REQUEST

Current Zoning: R-3 (single family residential)
Proposed Zoning: R-8MF(CD) (multi-family residential, conditional)

**STAFF
RECOMMENDATION**

Staff recommends approval of this petition upon resolution of outstanding issues related to site and building design.

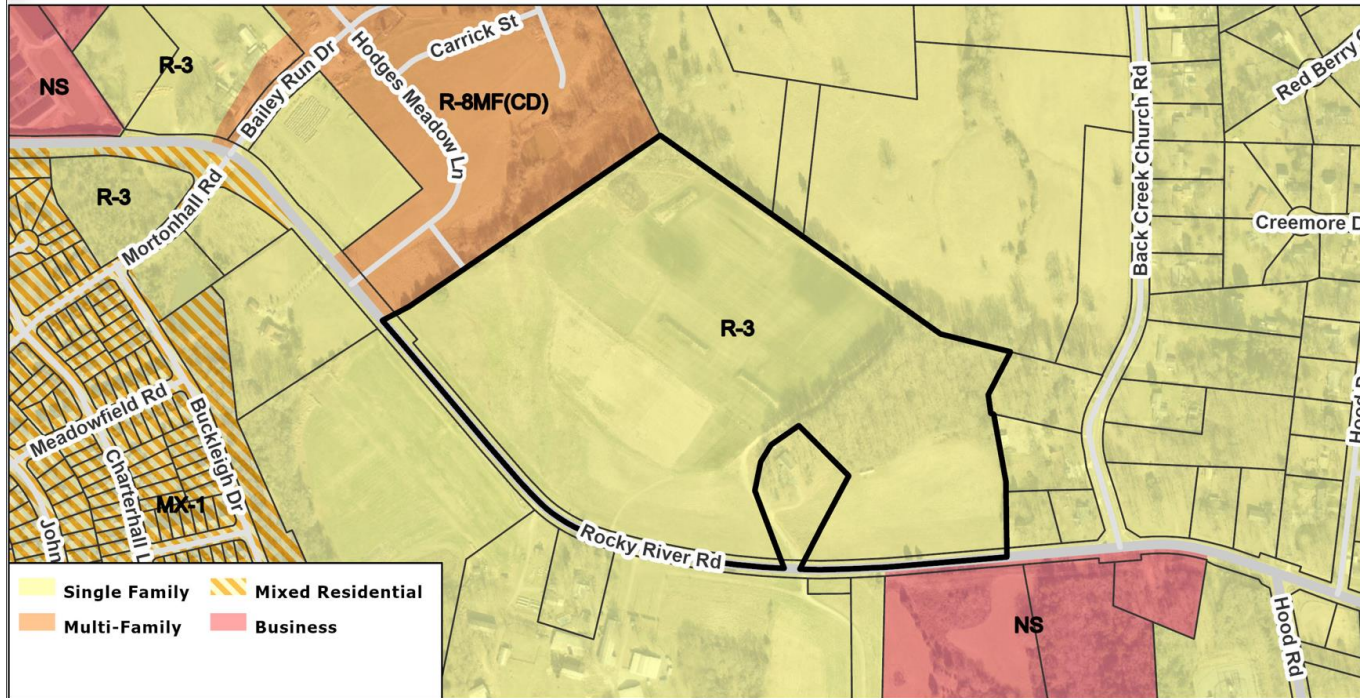
1. 4-foot Median is to be constructed on Rocky River Road. Label, dimension, and commit to proposed median. Addressed

2. The proposed berm shall be removed from the park dedication area. Addressed
3. The note needs to be revised to state that the 1.5 acres proposed park shall be dedicated and conveyed to Mecklenburg County for a future neighborhood park. Addressed
4. The site data table shows 15% tree save but there is not 15% show on the plans. Site is located in a wedge so a min of 15% of the overall site is required to be shown as tree save. Addressed

5. Specify if townhomes are to be "land for sale". Addressed
6. Add townhomes to proposed use. Addressed
7. Add to site data table: density allowed, density proposed, number of units allowed, number of units proposed. Addressed

8. Future Eastern Circumferential Road. Because of the road type setback should be discussed with staff.
9. Show and label required side and rear yards based on building orientation. This applies to the overall property boundaries not the sublots. Addressed

10. The site must meet all planned multi-family requirements. Addressed
11. Setbacks and yards are based on planned multi-family requirements. Note as follows: Addressed

12. Show and label setbacks along all public streets. Addressed
13. Please clarify if this the minimum 50% open space required for R-8MF if so remove useable common. Addressed

14. Sublots cannot be in the buffers. Addressed
15. Buffers start at the setback. Addressed
16. If any buffers are being reduced it must be noted. Addressed

17. The 20-foot garage setback is measured from the back of sidewalk or right-of-way whichever is greater is a reduced setback is used along local streets. Addressed

18. Building separation is a minimum of 16 feet. Addressed
19. The 27ft. setback can be reduced to 15ft. per section 9.303(19)(f) of the zoning ordinance if all conditions of that section are met but all garages must meet the 20ft. setback. All corner lots must also meet all requirements (including an entrance doorway on both side) if the 15ft. setback is being used. If the reduced setback is to be used this information must be noted in the site data table.

20. Please clarify if the proposed pathway internal to the development is intended to have connections to the parking lot abutting the proposed public park. Rescinded

21. Development Data Table references the 50-foot Class C buffer, but not the 30-foot Class C buffer provided adjacent multi-family. Not addressed
22. **New comment resulting from revised site plan dated 5/18/2023:** Previous site plans submitted state total 38.25 acres, while most recent plan states 42.46 acres. Please confirm which acreage is correct.

23. New comment resulting from revised site plan dated 5/18/2023: Add to Site Data Table – "15 ft. setback per Section 9.303(19)(f) of the zoning ordinance. Not addressed
